# Access Compliance Report

## Public Rights-of-Way

### (Curb Ramps)

Intersection ID: N/A	Main Street: BROOKSVALE_ST	Cross Street: N/A	Location: NW
ADA ID: E0ADA7E0FF45	Ramp Type: Perp	Initial Pass/Fail: Fail	Overall Compliance: No
Severity Score: 13.75			
Codes/Mitigation Info/Possible Solution		Field Measurements/Component Compliance

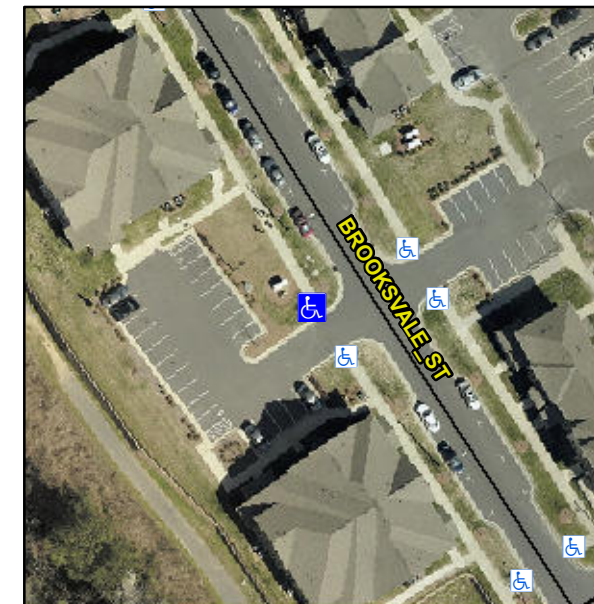
PROW/ADA:

**R304.2.2, R304.5.3**

Compliance	Description	Data	Compliance	Description	Data
N/A	Ramp Length (in)	73.0	No	Ramp Slope (%)	8.9
Yes	Ramp Width (in)	70.0	No	Ramp XSlope (%)	3.0
N/A	Flare Type LT	N/A	N/A	Flare Type RT	N/A
N/A	Flare Slope LT (%)	N/A	N/A	Flare Slope RT (%)	N/A
N/A	Flare Traversable LT?	N/A	N/A	Flare Traversable RT?	N/A
N/A	Landing Length (in)	N/A	N/A	DWS Provided?	N/A
N/A	Landing Width (in)	N/A	N/A	DWS Contrast?	N/A
N/A	Landing Slope (%)	N/A	N/A	DWS Length (in)	N/A
N/A	Landing X Slope (%)	N/A	N/A	DWS Full Width?	N/A
N/A	Landing Curb? (Y/N)	N/A	N/A	DWS Offset (in)	N/A
N/A	Shared Landing?	N/A			
N/A	Gutter Ponding?	N/A	N/A	Gutter Slope (%)	N/A
N/A	Gutter Lip Ht (in)	N/A	N/A	Gutter X Slope (%)	N/A
N/A	Painted X Walk1?	No	N/A	Painted X Walk2?	N/A
	X Walk 1 Direction	To S		X Walk 2 Direction	N/A
N/A	X Walk 1 Width (in)	N/A	N/A	X Walk 2 Width (in)	N/A
	X Walk 1 Slope (%)	1.8		X Walk 2 Slope (%)	N/A
	X Walk 1 X Slope (%)	0.9		X Walk 2 X Slope (%)	N/A

**Remove & Replace Entire Ramp.**
